Sub: 82वीं संरक्षण समन्वय उप-समिति (पीसीसी) बैठक का कार्यवृत्त/ Minutes of 82nd Protection Coordination Sub-Committee (PCC) Meeting

82nd Protection Coordination Sub-Committee Meeting

Date: 21/08/2025 (Thursday)

Event 1: At 05:15 Hrs of 21-06-2025

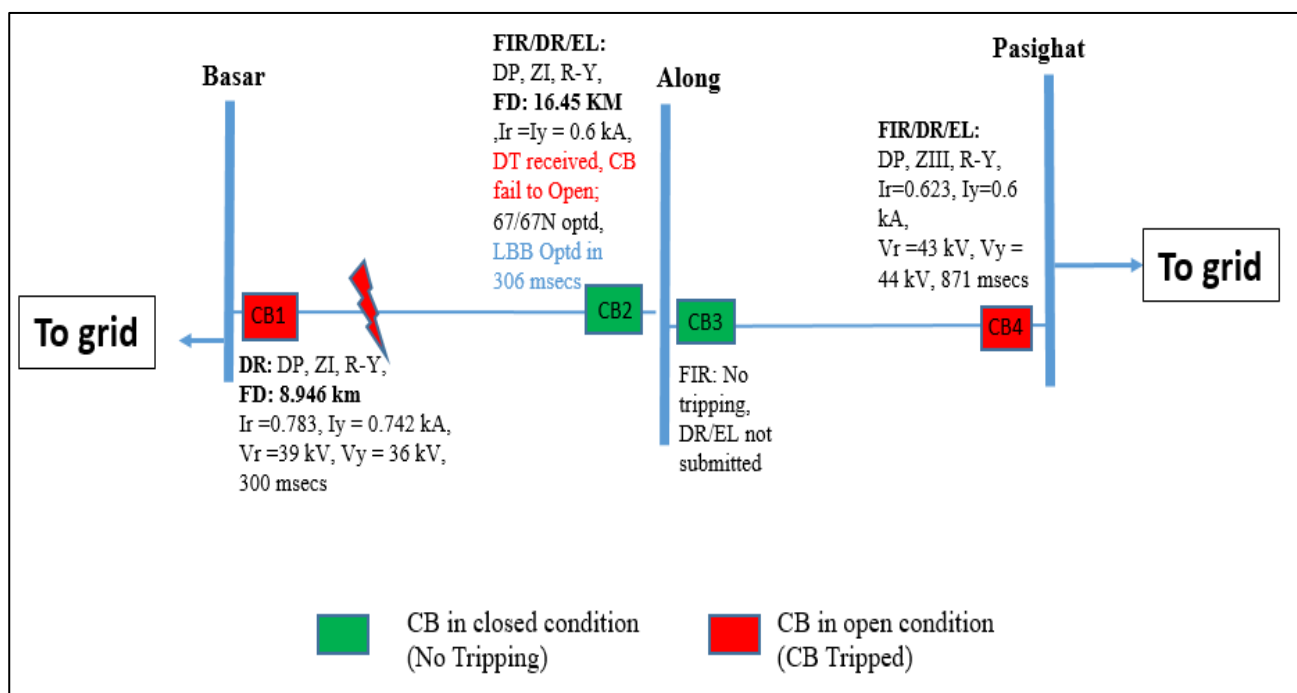
As per DR analysis, resistive R-Y fault (I_r -0.783 kA, I_y -0.742 kA) initiated at 05:14:17.444 Hrs in 132 kV Basar-Along line which was cleared within 300 msec from Basar end on operation of DP, ZI (delayed CB opening). However, CB fails to opens from Along end despite issuance of trip command by distance protection relay in ZI and the fault continued to feed from Roing side till 871 msec. The fault was cleared from Roing end of 132 kV Pasighat - Roing line after 871 msec on operation of DP, ZIII.

Event 2: At 16:52 Hrs of 23-06-2025

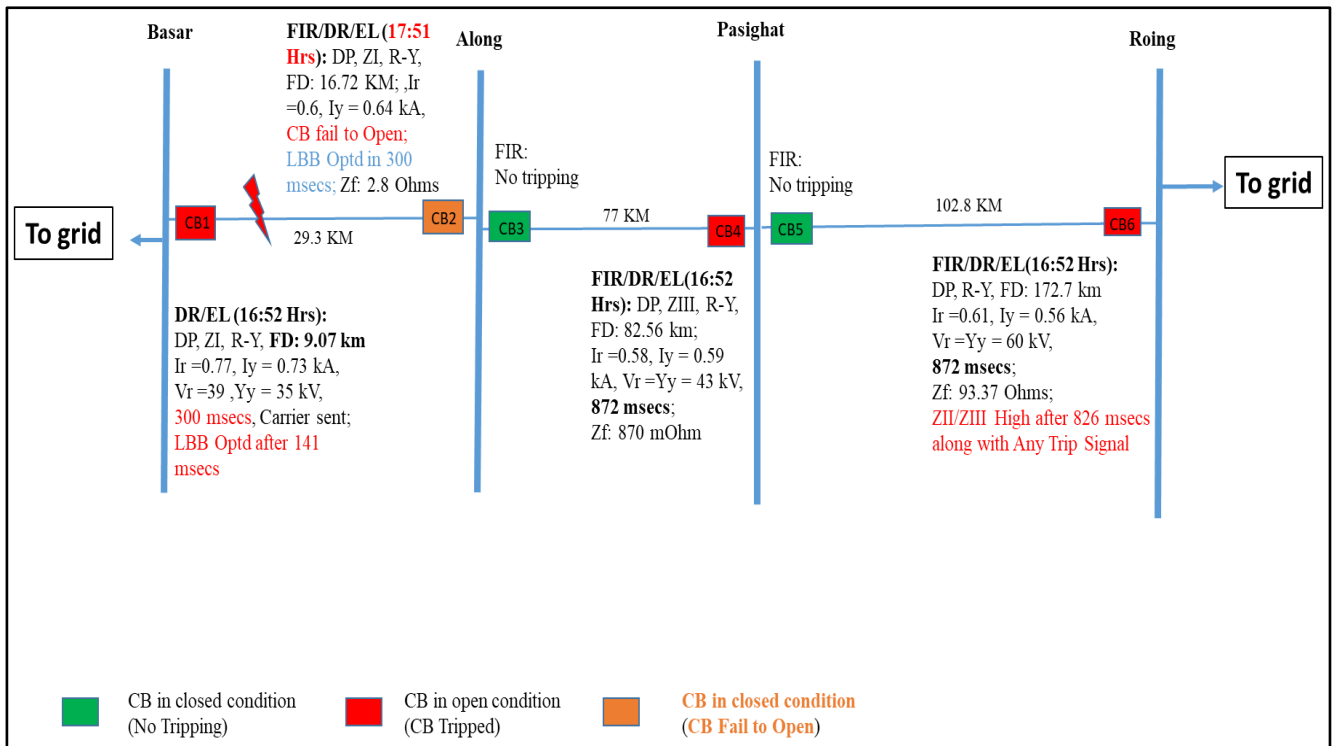
- **LBB protection at Along SS:** The Disturbance Recorder of the 132 kV Basar–Along line at Along shows that the LBB operated only after 300 milliseconds, despite a breaker failure (CB2 stuck) condition. DoP, Arunachal is requested to confirm the reason for non-operation LBB at Along SS during the CB stuck condition. Also, make necessary modification/corrective on immediate basis.

2. Regarding delayed operation of CB at Basar (CB1), DoP Ar. Pradesh informed that the issues will be resolved in coordination with COMPREHENSIVE team.
3. Regarding LBB protection at Along SS, there is LBB wiring issue. To be rectified.
4. Regarding DT received at CB (CB2) at Along, DoP Arunachal Pradesh informed that issue will be resolved in coordination with COMPREHENSIVE team.
5. For Event 2, Regarding zone 3 operation of CB6, PGCIL informed that Zone 3 reach settings were modified earlier but issue persisted. He raised the doubt over correctness of line lengths. He requested DoP Ar. Pradesh to provide the distance of 132 kV Along -Pashighat line so that zone 3 reach can be correctly modified. POWERGRID informed that Offline fault locator of 132 kV RoingPasighat line to be carried out to ascertain the exact line length.

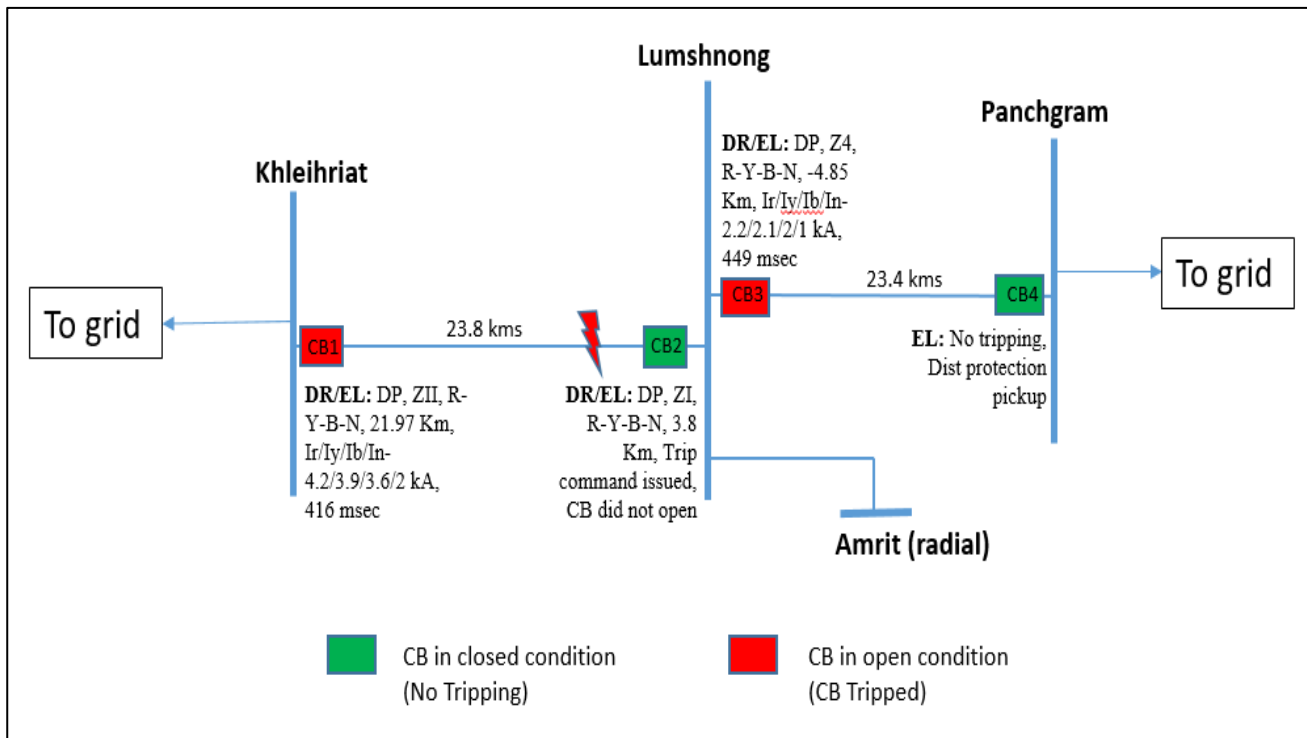
As per DR analysis, R-Y-B-N fault (Ir-4.2 kA, Iy-3.9 kA, Ib-3.66 kA, In-2 kA) initiated at 23:24:29.571 Hrs in 132 kV Khleihriat-Lumshnong line which was cleared within 416 msec from Khleihriat end on operation of DP, ZII. From Lumshnong end, ZI trip command issued 23:23:42.094 Hrs. However, CB did not open. As a result of which fault was continuously feeding from Panchgram end.

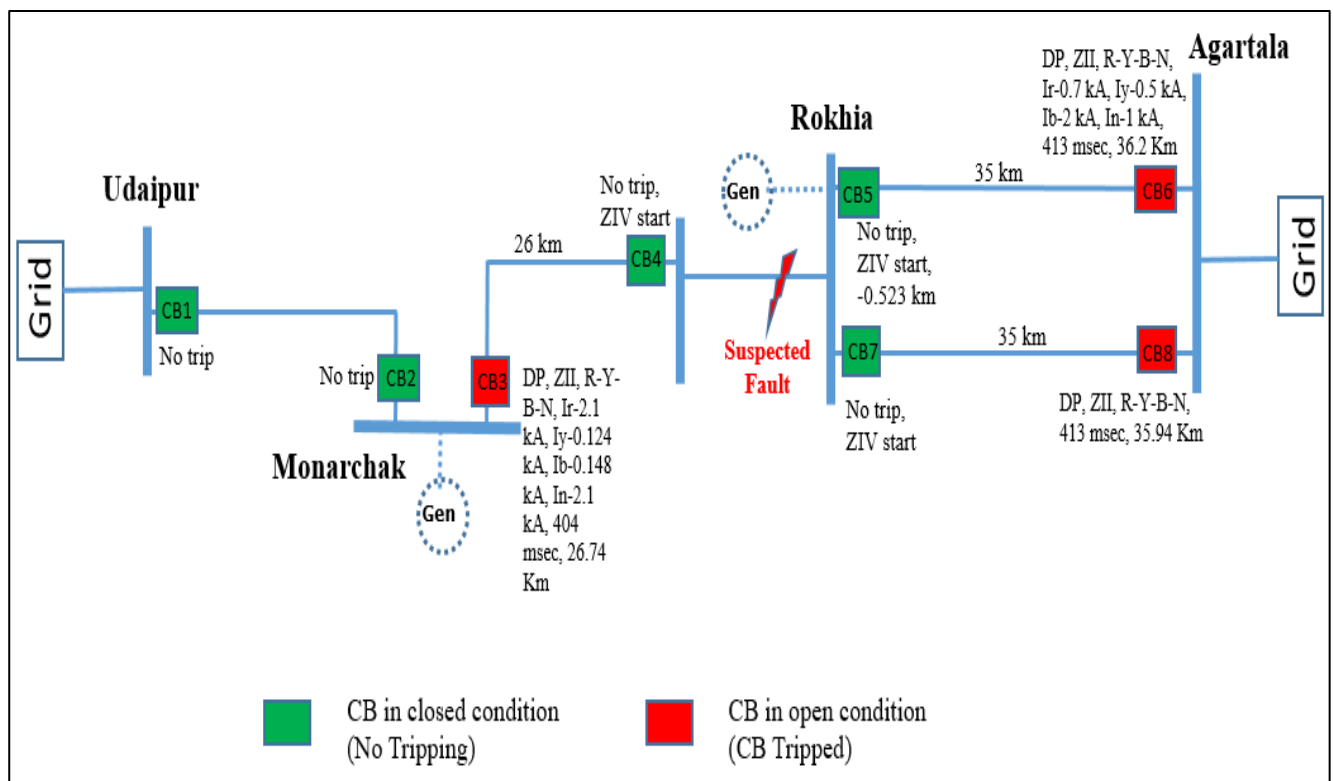
Suspected R-Y-B-N fault of solid nature in Rokhia S/S or 132 kV Old Rokhia-New Rokhia Link feeder which was cleared by tripping of all the healthy lines connected to Rokhia S/S from remote ends on operation of DP, ZII.

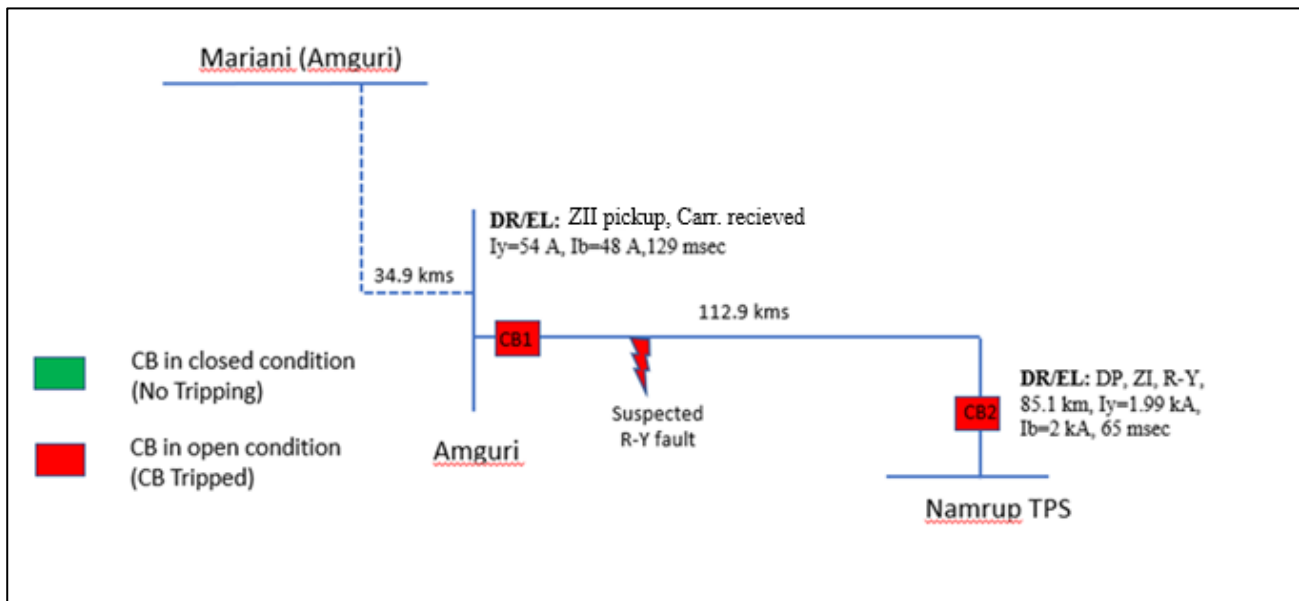
As per DR analysis, Y-B fault (I_y - 1.99 kA, I_b - 2 kA) initiated at 15:19:29.0520 Hrs which was cleared within 65 msec from Namrup TSS end. From Amguri end, Carrier/ DT received (I_y - 54 A, I_b - 48 A).

- DEF based carrier added protection in case of IBR related protection.
- Weak Infeed Echo scheme.

Event 1: At 06:42 Hrs of 29.05.2025

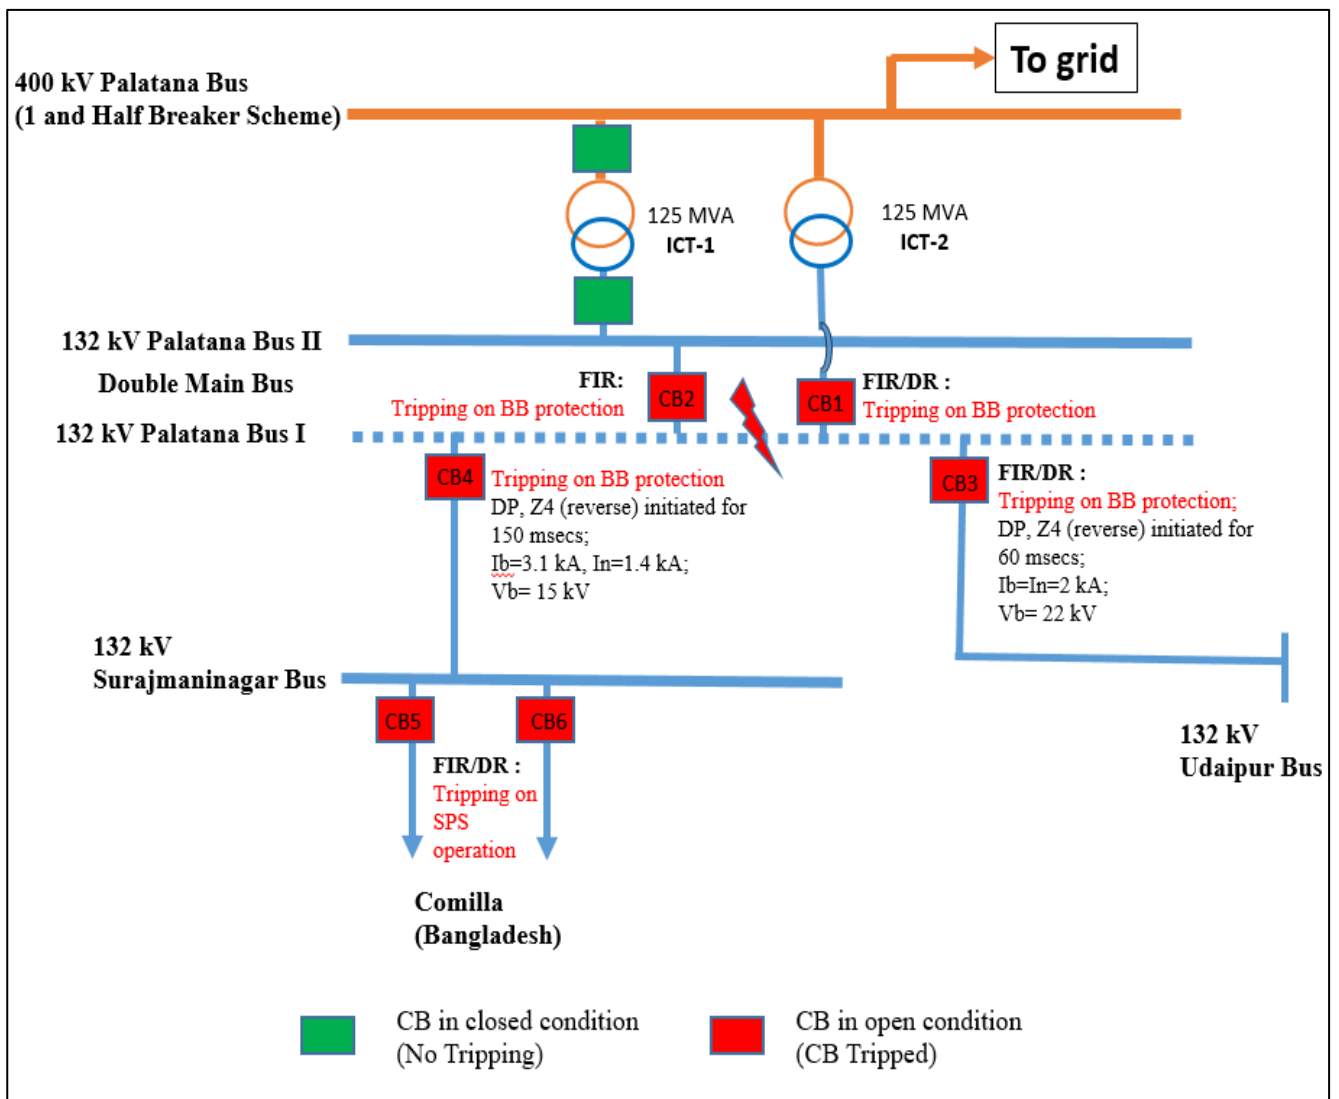
As per DR analysis, B-N fault of metallic nature initiated likely in the 132 kV Surajmaninagar Bus I which was cleared on operation Bus bar protection of 132 kV Main Bus I in 70-80 msec.

Event 2: At 13:08 Hrs of 29.05.2025

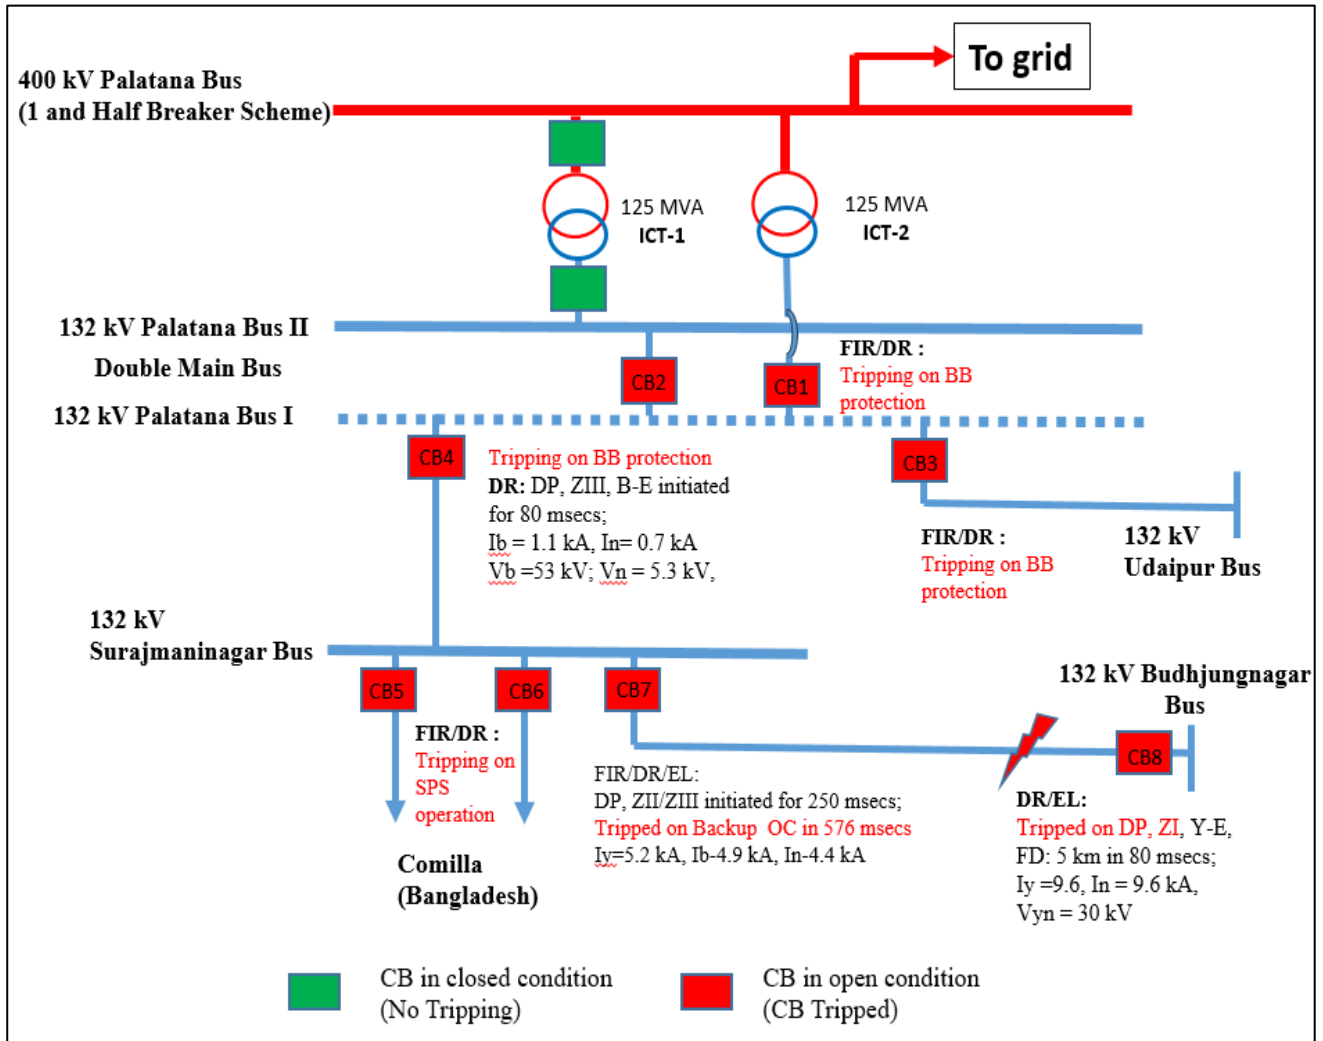
As per DR analysis, Y-N fault of metallic nature initiated at 13:08:01.059 Hrs in 132 kV Surajmaninagar – Budhjungnagar line which was cleared from Budhjangnagar in 80 msec on DP, ZI & Surajmaninagar in 576 msec on operation of B/U O/C protection (ZII/ZIII started and deactivated after 250 msec)

OTPC & TSECL may update share the root cause and provide update on the above mentioned issues.
